Docket No. 50-336
B18766

Millstone Power Station, Unit No. 2
Response to a Request for Additional Information
Technical Specifications Change Request (TSCR) 2-10-01, Revision 2
Fuel Pool Requirements

Response to a Request for Additional Information
Technical Specifications Change Request (TSCR) 2-10-01, Revision 2
Fuel Pool Requirements

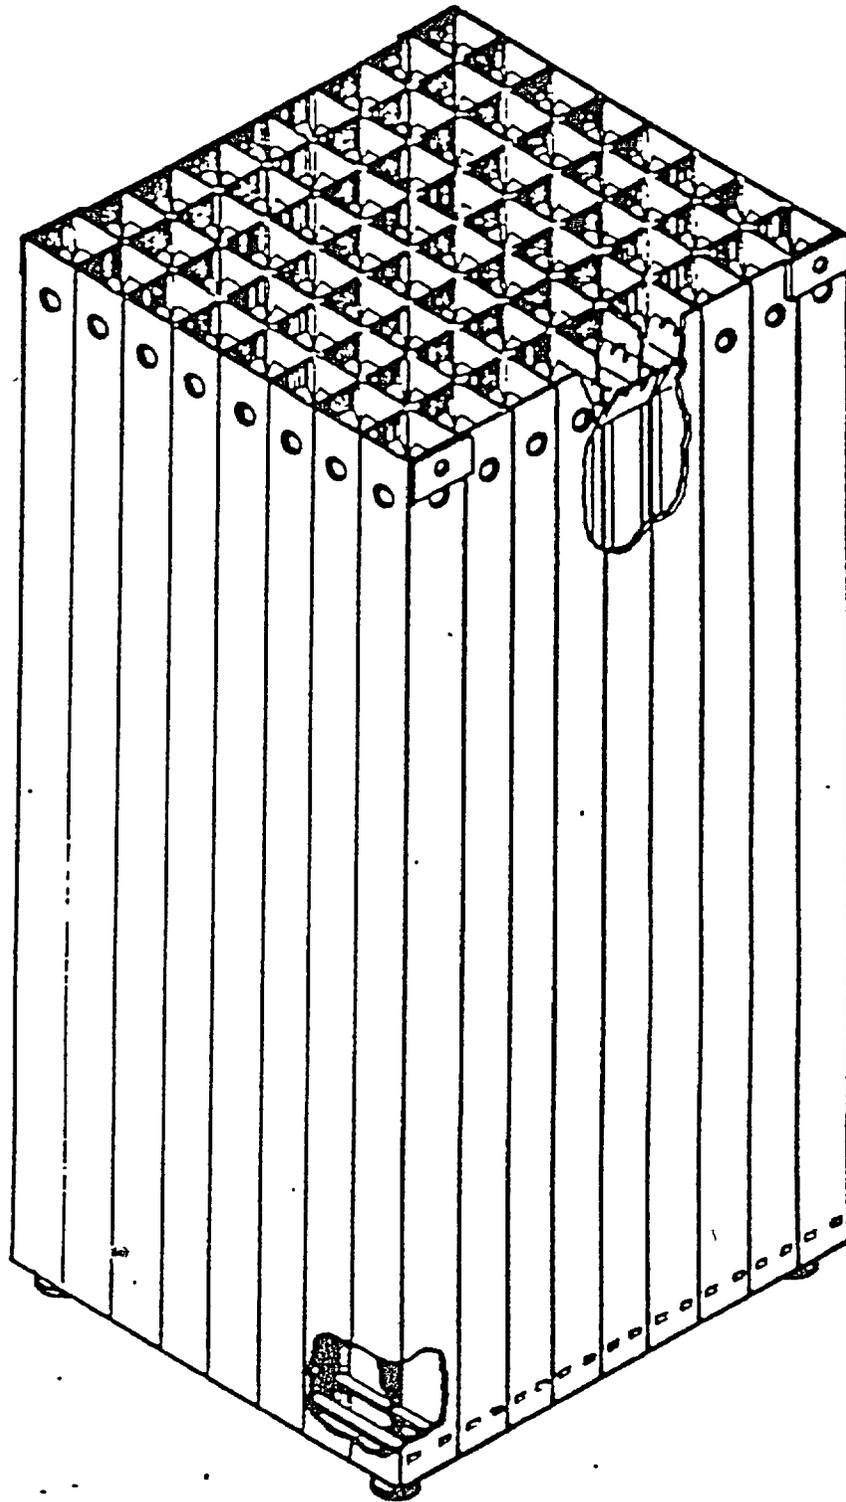
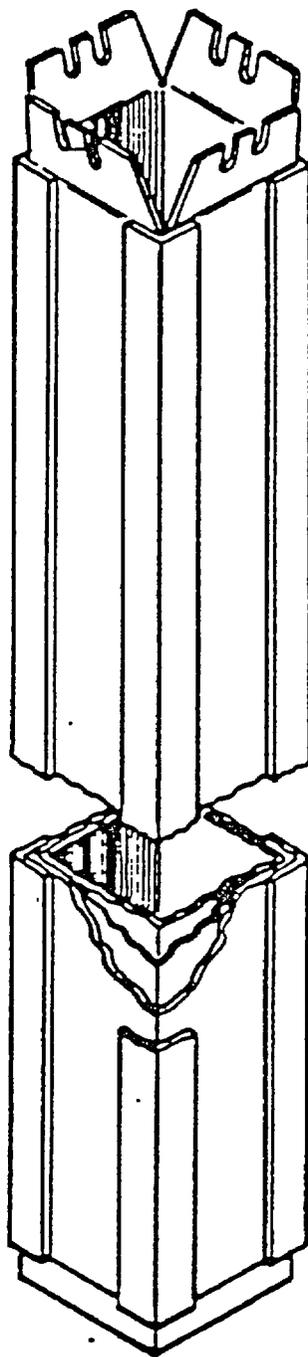
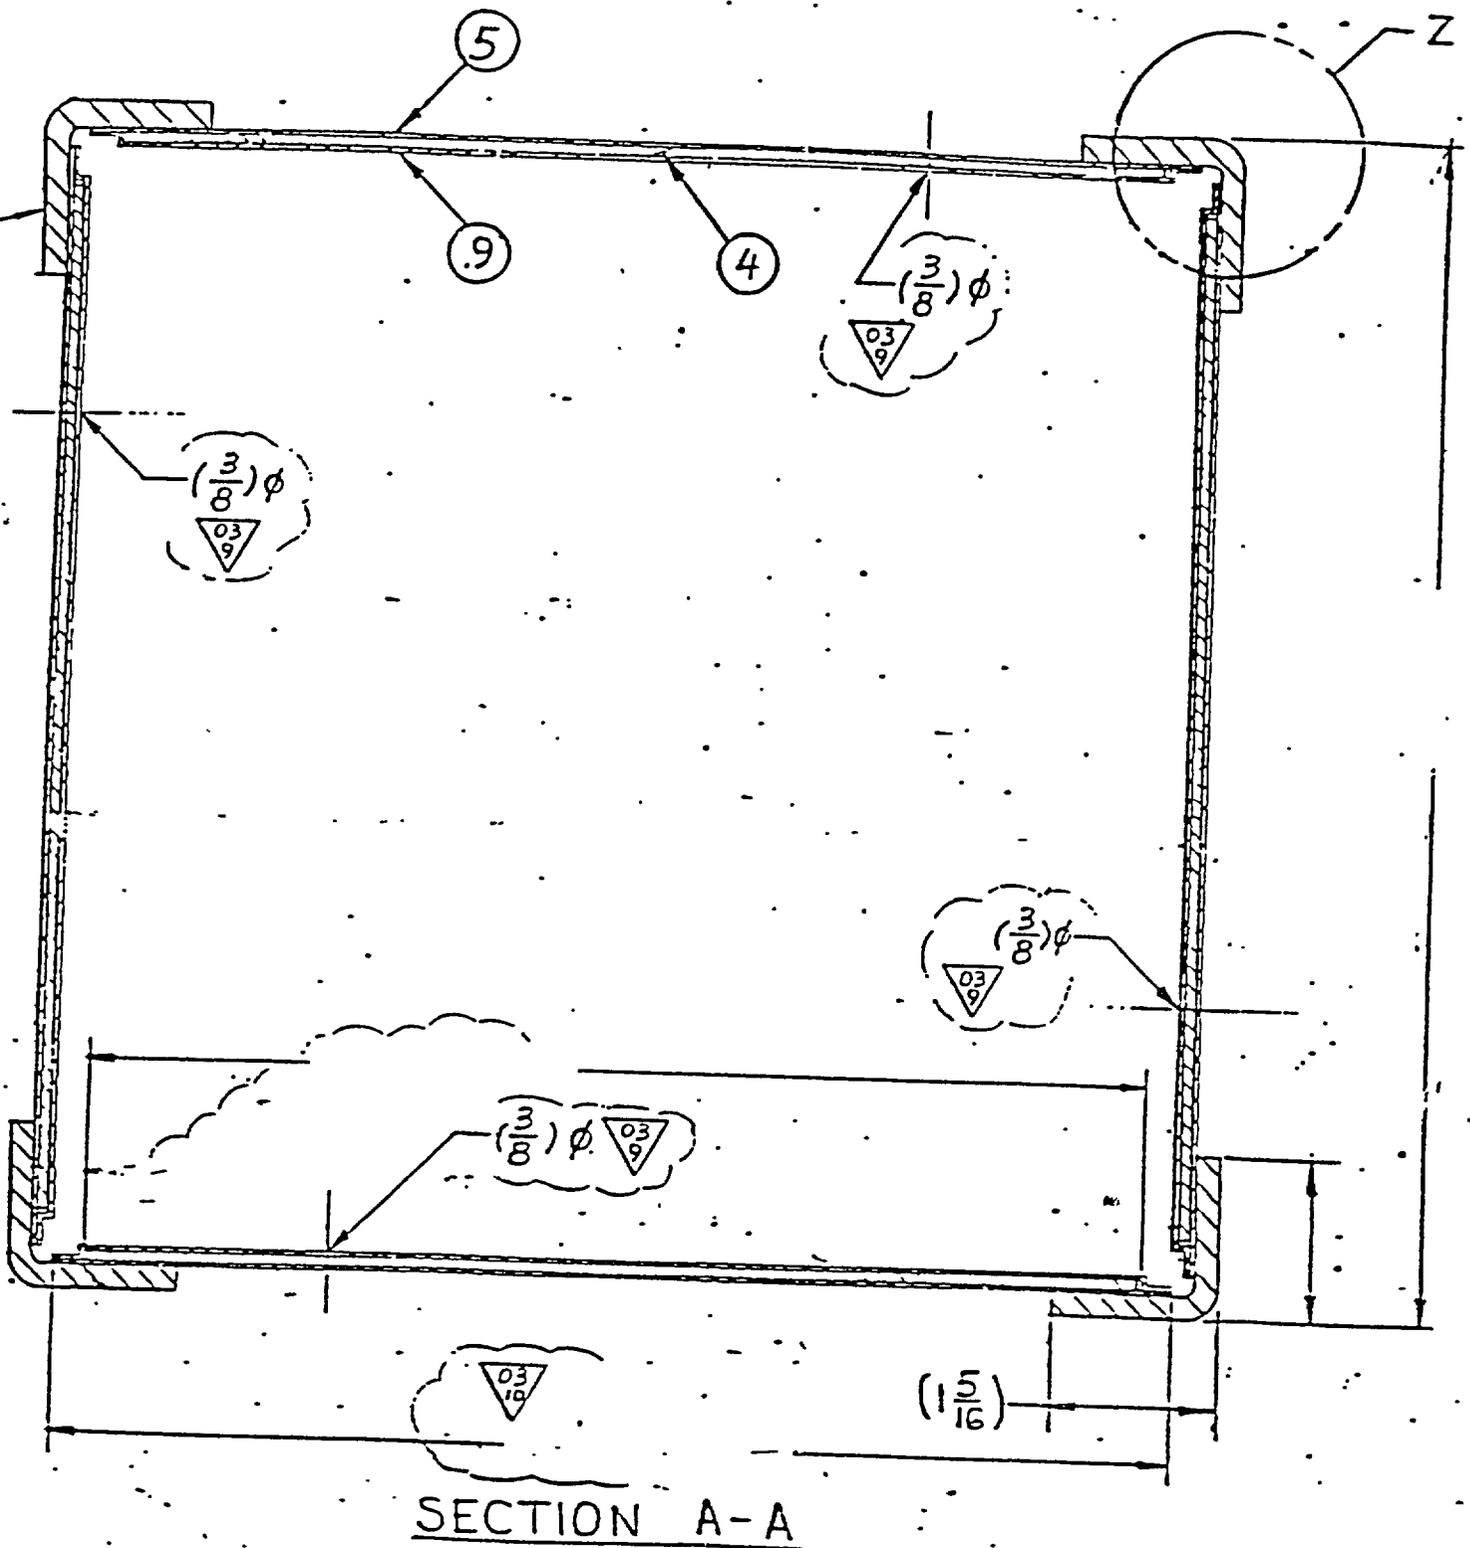
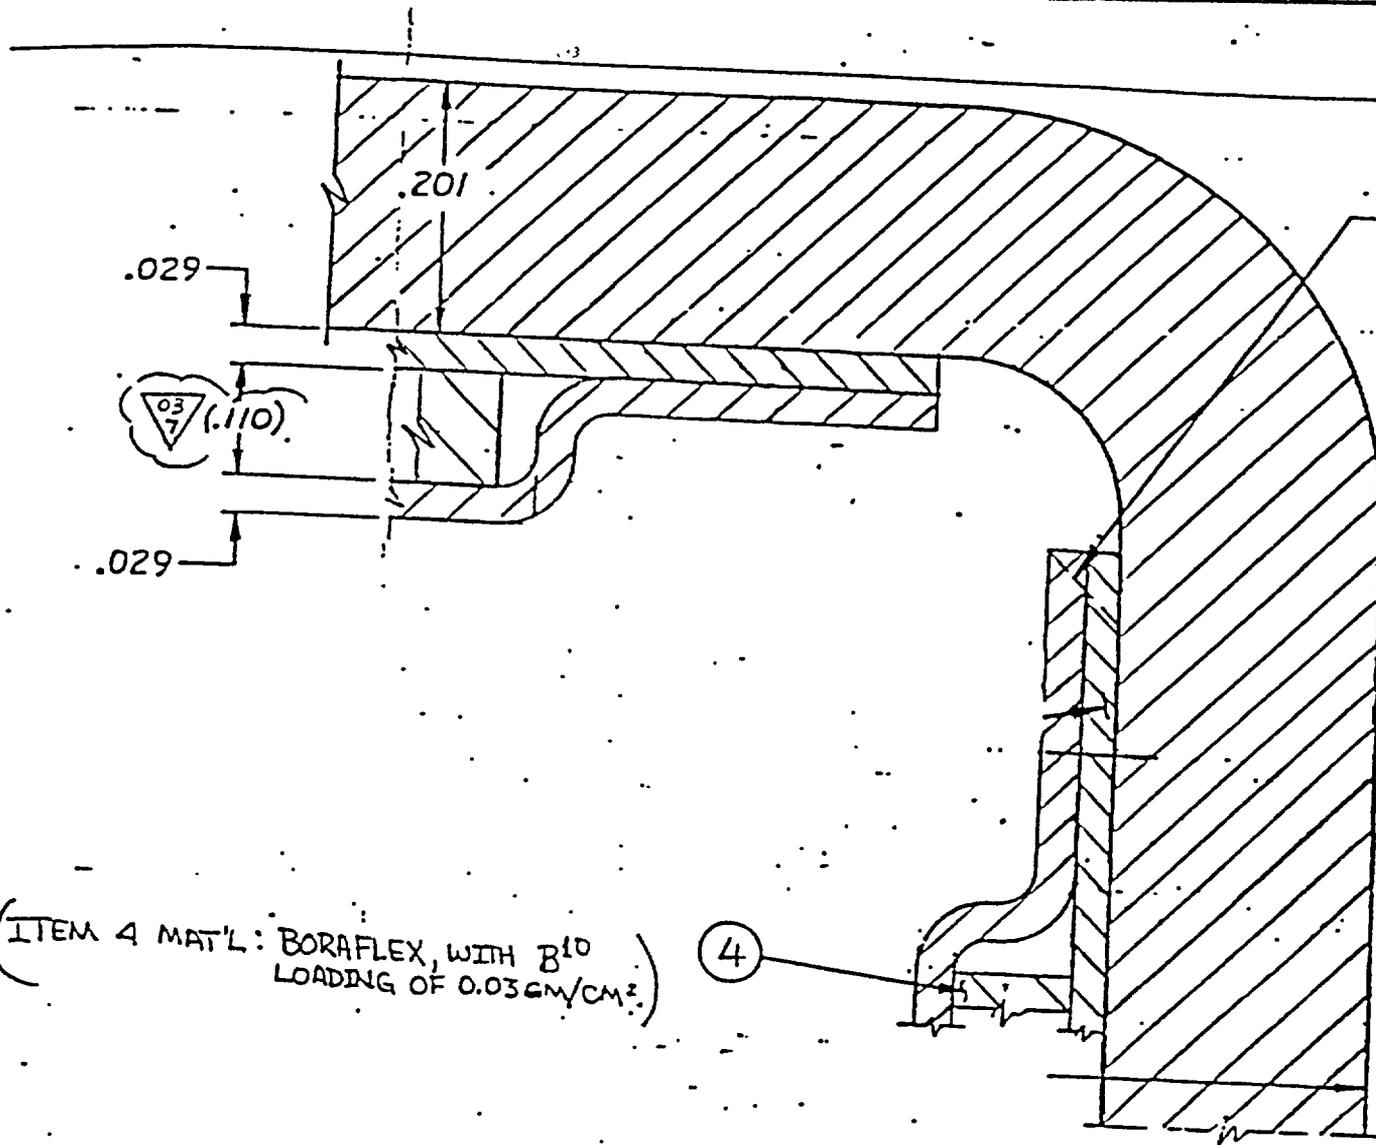
How long have RACKLIFE and destructive examinations of poison panels been conducted? At what frequency are each completed?

The Millstone Unit No. 2 (MP2) spent fuel racks have removable Boraflex poison boxes which is a unique design feature. Each spent fuel storage location has its own Boraflex poison box. The poison box is securely attached inside each storage cell, and the fuel assembly rests inside the poison box. Attached are Figures 4-1, 4-4, 4-5 and 4-6 which show the spent fuel rack module (Figure 4-1), Boraflex poison box (Figure 4-4), and Boraflex poison box details (Figures 4-5 and 4-6). These figures were previously transmitted to the NRC in a letter dated July 24, 1985.⁽⁶⁾ A total of three Boraflex poison boxes have been removed from the MP2 Spent Fuel Pool (SFP). In 1991, two poison boxes were removed for visual examination to correlate blackness testing gap measurements and to provide a general examination of Boraflex performance in cooperation with the Electrical Power Research Institute (EPRI). These first two poison boxes removed in 1991 were not part of our formal Boraflex monitoring program. The third poison box was removed in the year 2000 as part of our current Boraflex monitoring test program. Future poison box removals as part of this Boraflex monitoring program are planned at approximately five year time intervals, and are controlled by plant procedures. The poison box removal program functions as the primary means of monitoring for Boraflex dissolution. Testing of this Boraflex is performed by a qualified vendor 10 CFR 50, Appendix B quality assurance (QA) program.
